XV TRANSVERTER OWNER'S MANUAL ERRATA

Rev. F1-3, August 27, 2016

E740096E

XV50 R.F. Circuits Schematic
(R.F. Board)

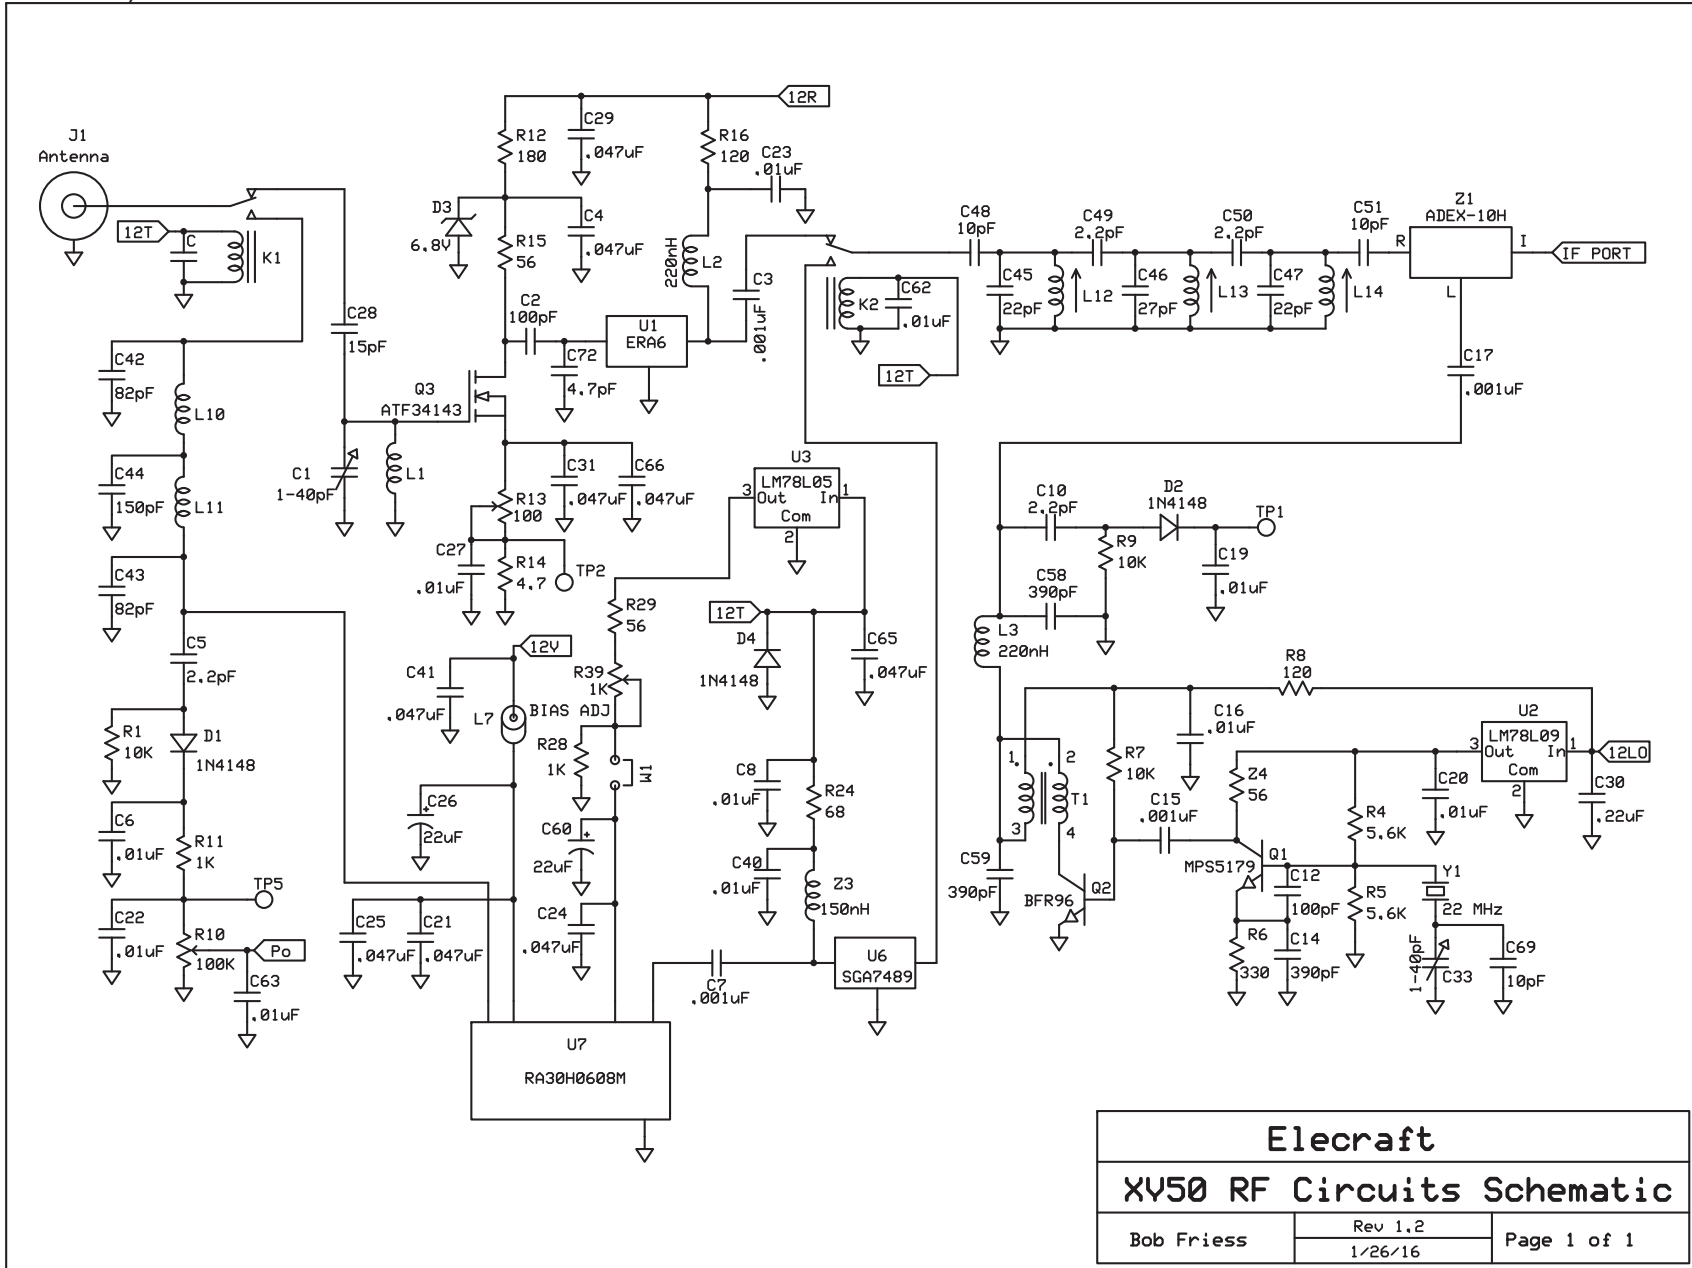
1. **Appendix A, Page A-6:** Replace the page with page 2 of this errata. The updated schematic includes Resistor R7 that was missing from the earlier version.
2. **Page A-11, XV432 RF Circuits Schematic (RF Board):** Change the diode type for D17 from 1N4148 to 1N5711. D17 is at the bottom of the diagram near the center.
